TECHNICAL BULLETIN

GOT-A-0283-A

Change of the LCD (Display Device) of the GT2507T-WTSD

GOT2000 Series (GT2507T-WTSD)

2 Details of the change

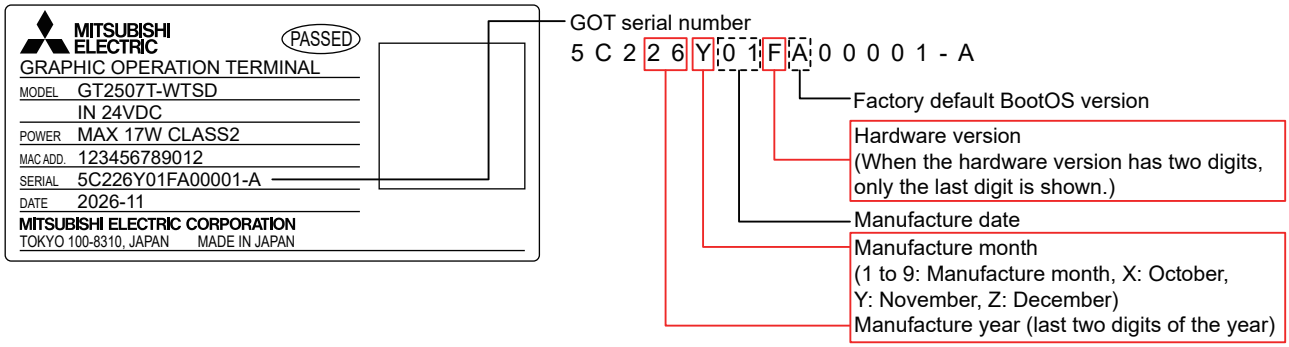
This change does not affect the general specifications, product specifications, functions, and external dimensions of the GOTs.

However, colors on the LCD and display characteristics may be slightly different.

The LCD (display device) will be changed.
